Addendum Number: 03

Addendum Issue Date: April 28, 2025

Project Name: Robinson Washington Elementary
Renovation & Addition

Project Number: 02401781.001

OVERALL ROOF MECHANICAL PLAN

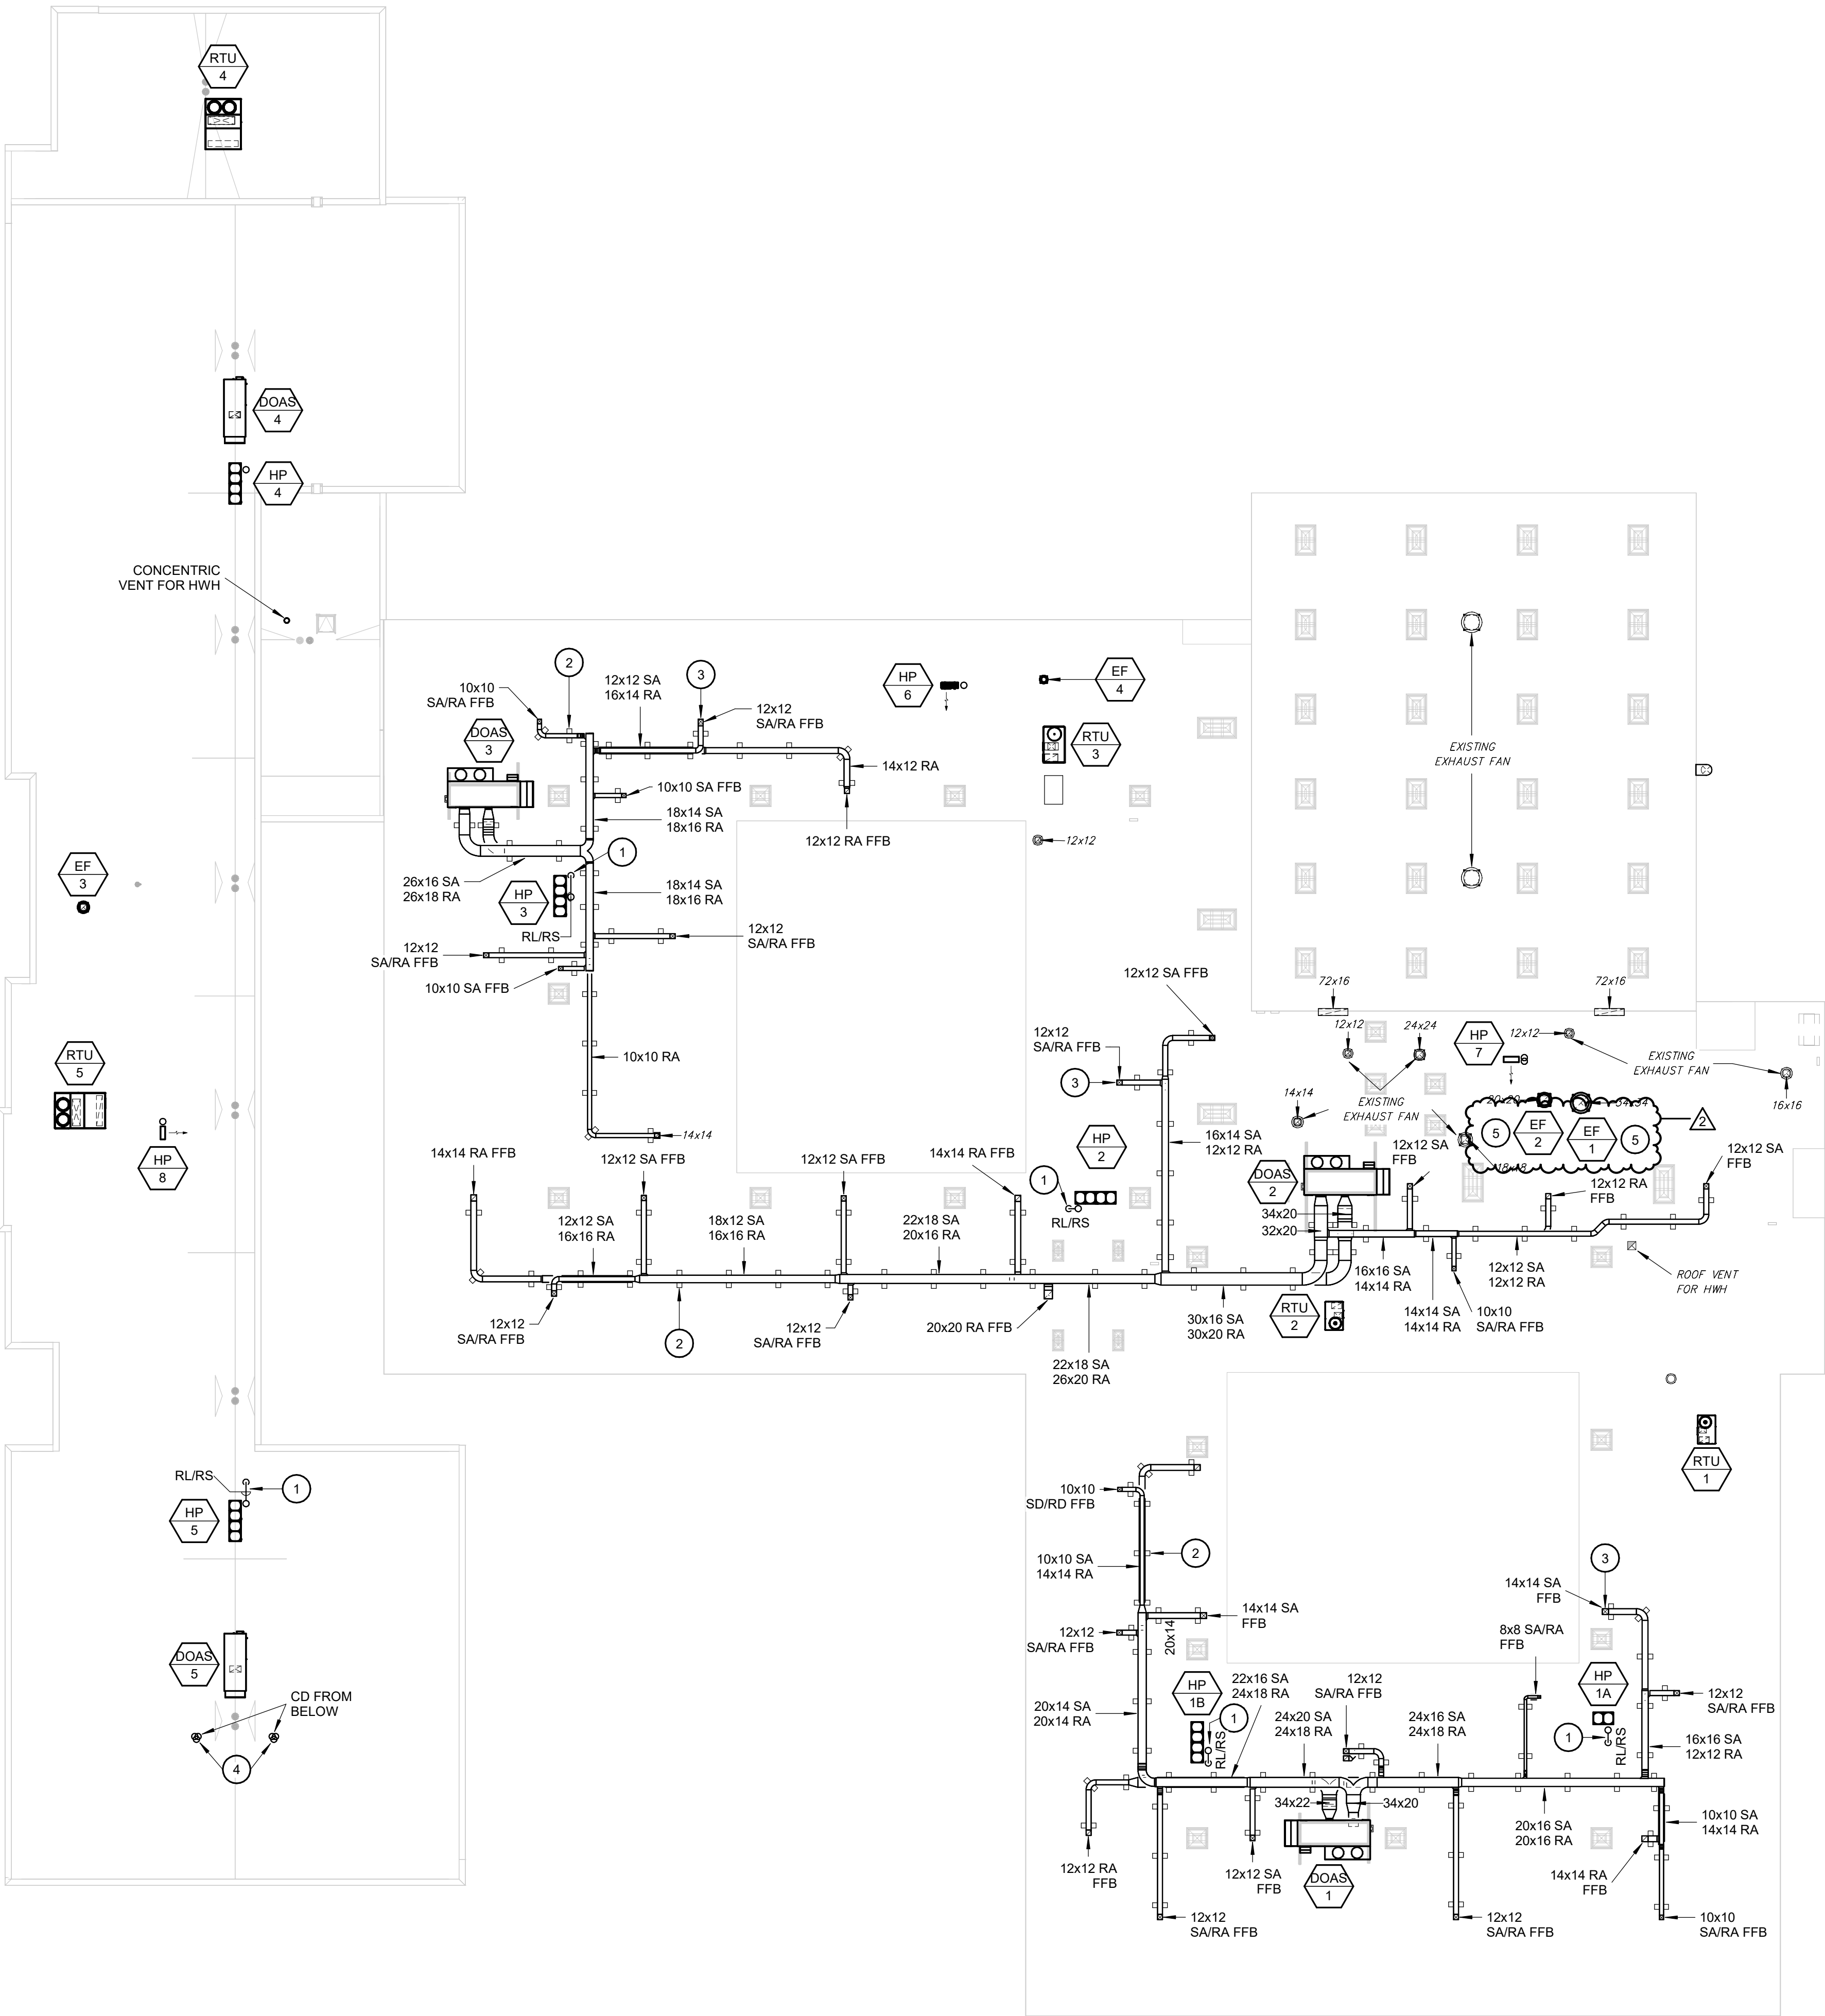
- b. ADD keynote #3.
10. M1.4 – OVERALL ROOF MECHANICAL PLAN
 - a. ADD keynote #5.
11. M2.1A – ENLARGED MECHANICAL PIPING FLOOR PLAN – AREA A
 - a. ADD VRF System control panel locations.

- PROVIDE REFRIGERANT PIPE ROOF SUPPORT. REFER TO PROJECT MANUAL FOR SPECIFICATION.
- PROVIDE ROOF DUCT SUPPORTS. REFER TO DETAILS ON SHEET M5.2 FOR MORE INFORMATION. MAXIMUM SPACING AS SPECIFIED IN PROJECT MANUAL. TYPICAL FOR ALL.
- SUPPLY AND/OR RETURN/EXHAUST DUCT DROPS DOWN THROUGH ROOF. SEE FIRST FLOOR PLAN FOR CONTINUATION. DUCT DROP SIZES AS NOTED.
- INSTALL PIPE PORTAL STYLE ROOF CURB FOR CONDENSATE DRAIN PENETRATIONS THROUGH ROOF. REFER TO DETAIL #1 ON SHEET M5.2 FOR MORE INFORMATION. ABOVE ROOF ROUTE CONDENSATE DRAIN PIPING TO DRAIN INDIRECTLY TO CLOSEST ROOF DRAIN.
- EXHAUST FAN SHALL BE INTEGRATED AND INTERLOCKED WITH EXISTING KITCHEN HOOD CONTROLS.

ENLARGED
MECHANICAL PIPING
FLOOR PLAN - AREA
A

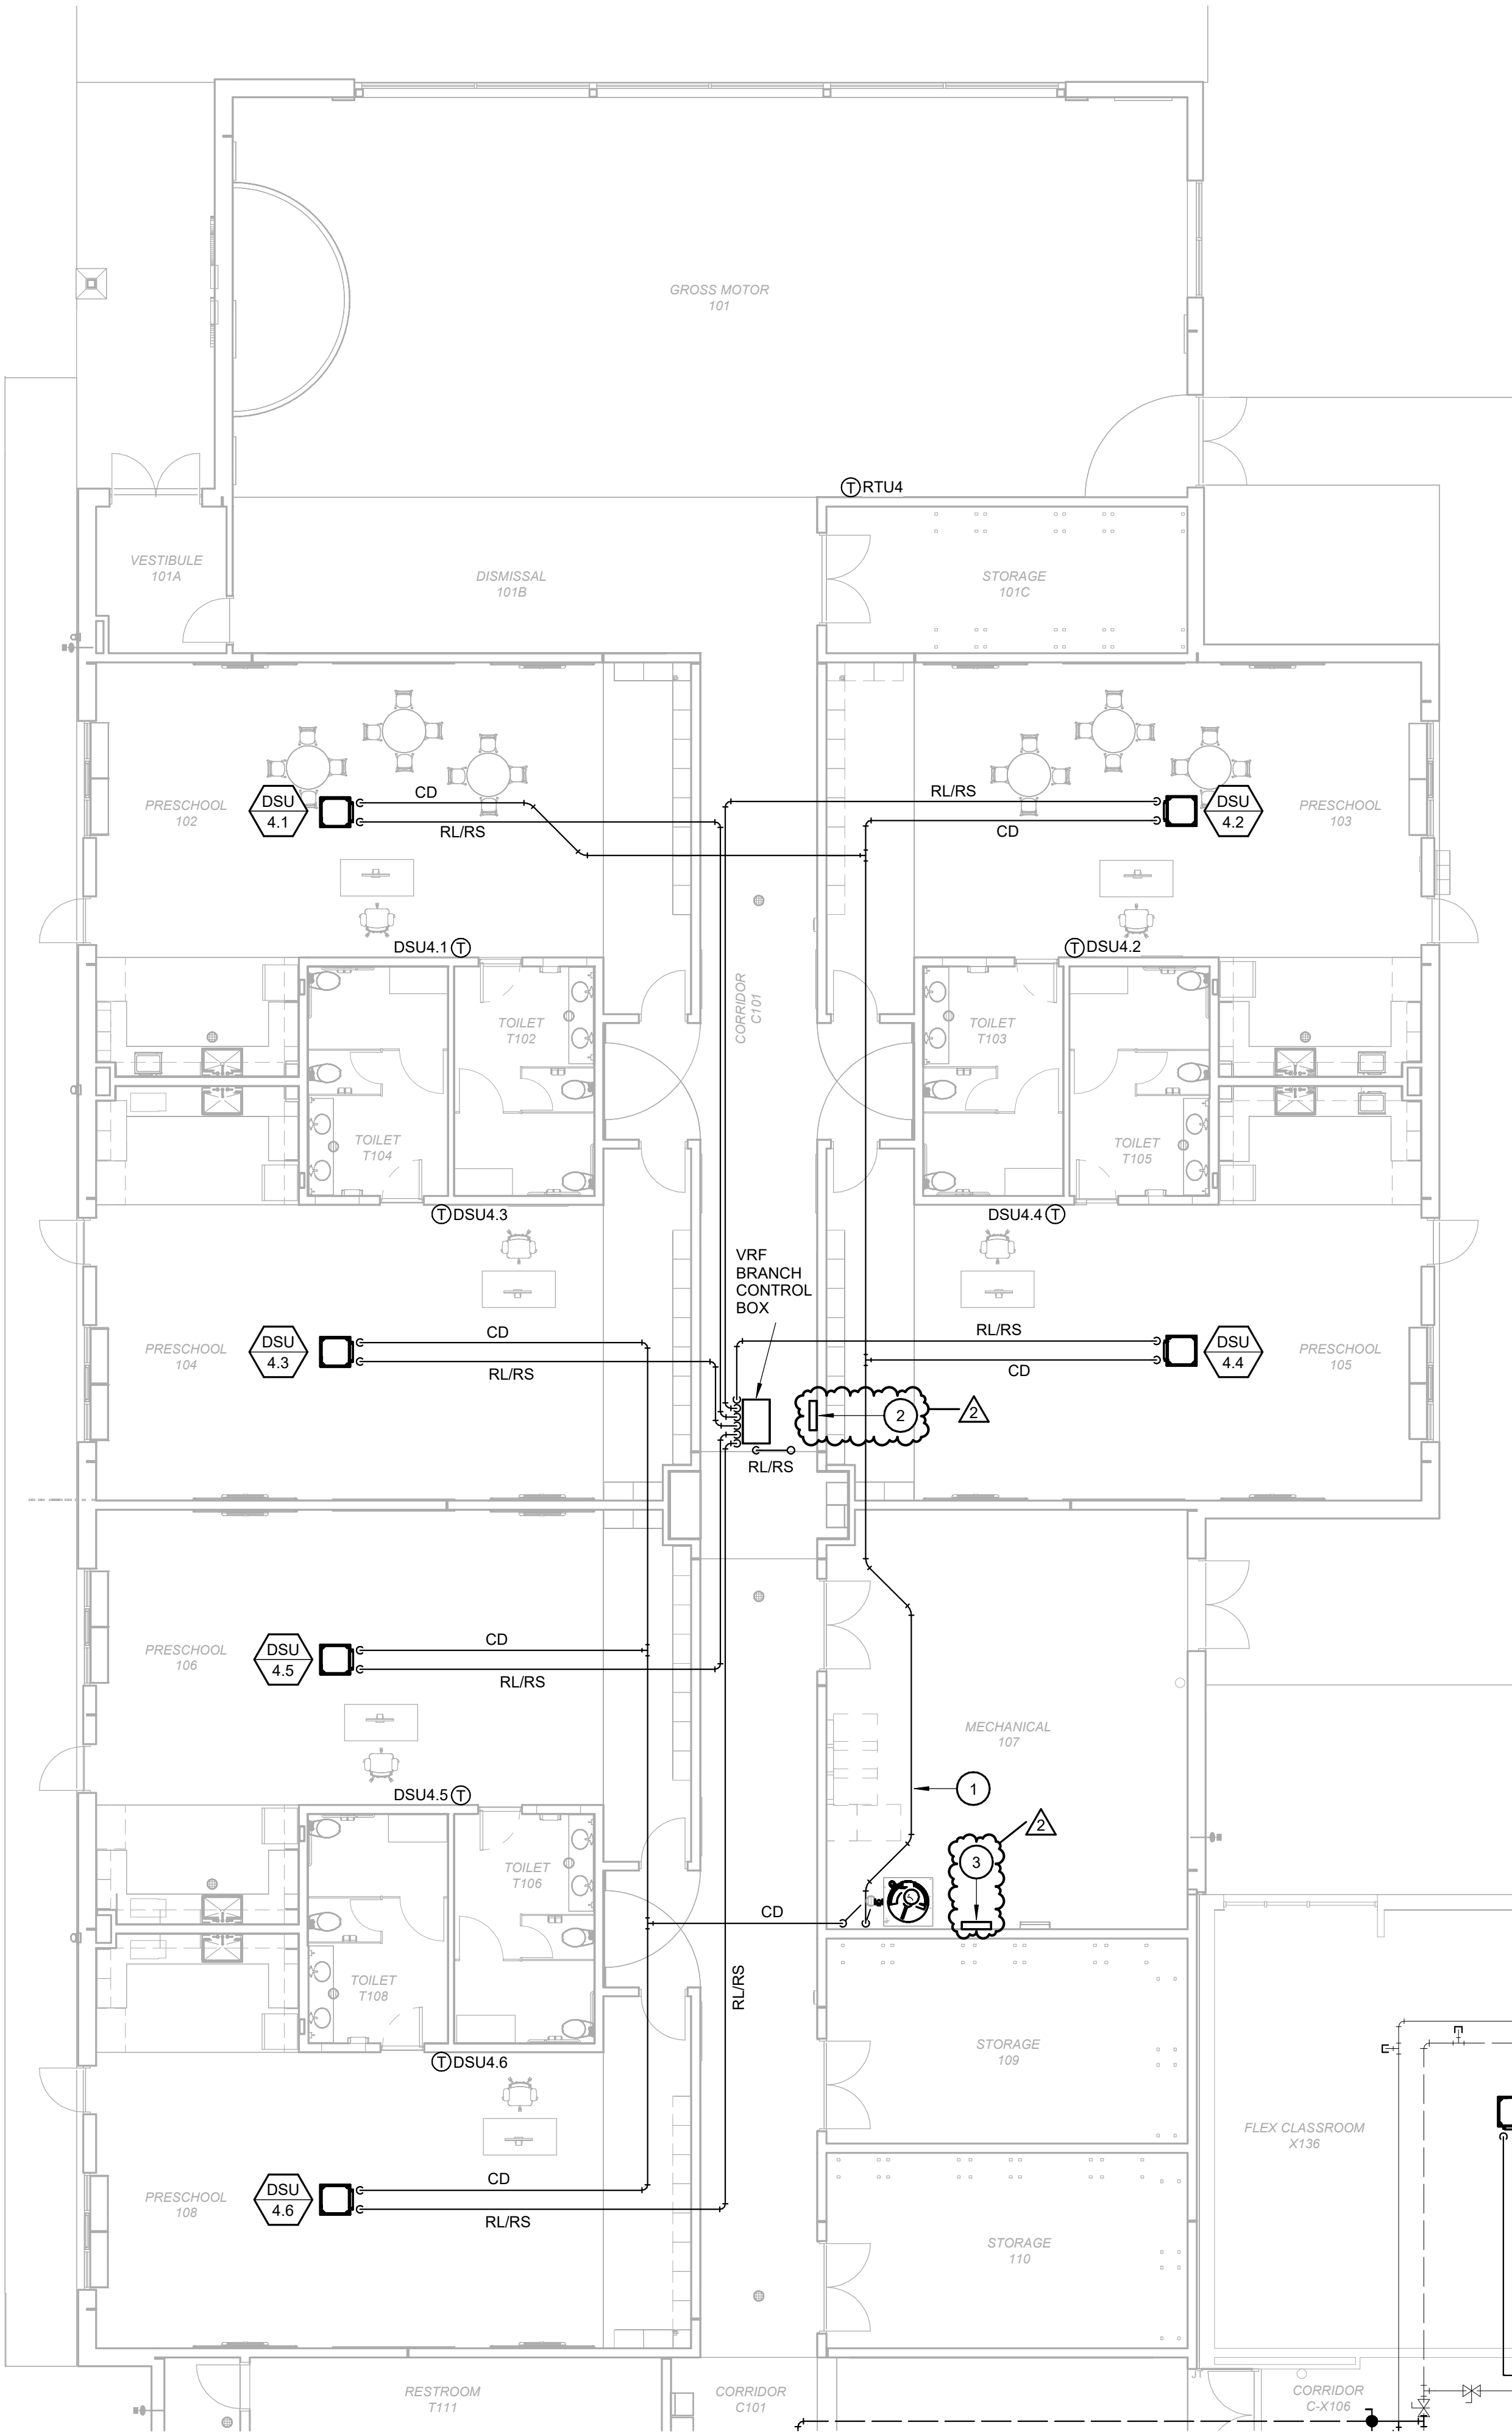
- b. ADD keynotes #2 and #3.
12. M2.1C – ENLARGED MECHANICAL PIPING FLOOR PLAN – AREA C
 - a. ADD VRF System control panel locations.
 - b. ADD keynote #2.

- 1 ROUTE CONDENSATE DRAIN TO AVOID ELECTRICAL PANELS.
- 2 VRF SYSTEM LOCAL CONTROL PANEL SHALL BE INSTALLED IN CORRIDOR NEAR VRF BRANCH CONTROL BOX. PROVIDE ALL NECESSARY LOW VOLTAGE WIRING TO VRF DUCTLESS UNITS, BRANCH CONTROL BOX, HEAT PUMPS AND MAIN BAS/VRF CONTROL PANEL.
- 3 MASTER VRF SYSTEM CONTROL PANEL SHALL BE INSTALLED IN MECHANICAL 107. PROVIDE ALL NECESSARY LOW VOLTAGE WIRING TO AUXILIARY VRF CONTROL BOXES.
